INA Service Info

Tensioner pulley 531 0851 10

Modified specifications

Photo 1: 531 0777 10 – Old tensioner pulley (979743)

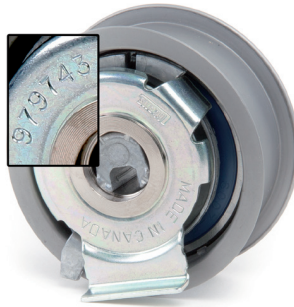
Due to modified specifications, the tensioner pulley 531 0851 10 replaces tensioner pulley 531 0777 10.

The only visual difference between the two tensioners pulleys is the number stamped on their rear face (fig. 1 and fig. 2).

Installation of the tensioner pulley with the number 979743 in place of the tensioner pulley with the number 979830 is not permitted.
